**Internal procedures for Solar Keymark WP1.A  
and input to CEN/TC 312**

**Version: 2  
2003-01-10**

Solar Keymark  
WP1.A  
Network for implementing standards  
Solar Collectors

## Comments to EN 12975-1

Right Figure 5

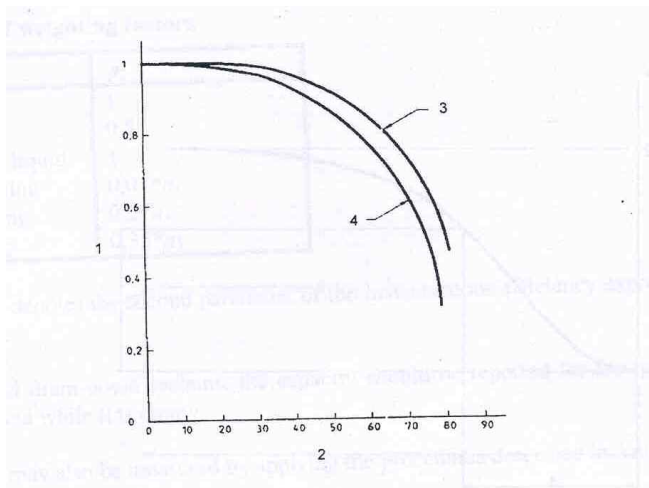
**Comment 10: Illustrations**

In 6.1.7.1 the Figure 5 is wrong figure and should be the one shown below.

Figure I.3

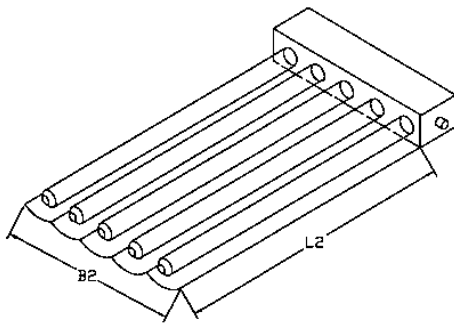
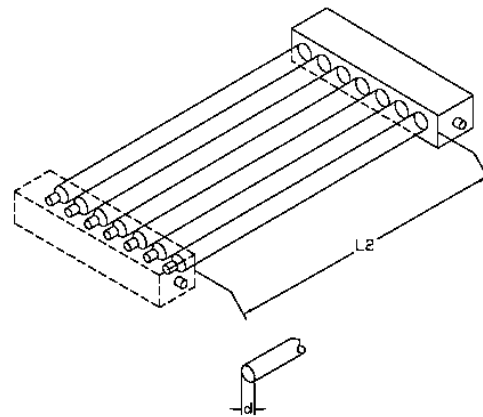
**Comment 11: Illustrations**

In Annex I the Figure I.3 is wrong figure and should be the one shown below.

*Right Figure I.3*

Figure I.5

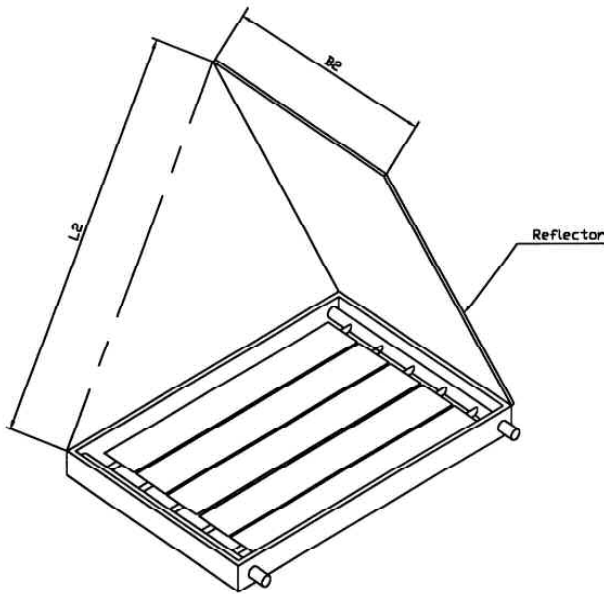
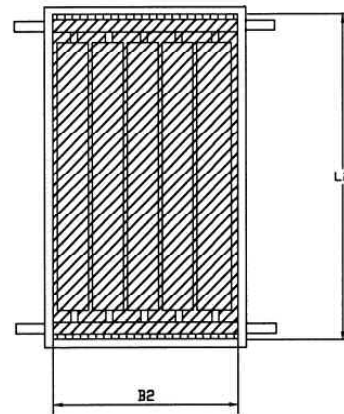
**Comment 12: Illustrations**

In Annex I the Figure I.5 is wrong figure and should be the one shown below.

*Right Figure I.5*
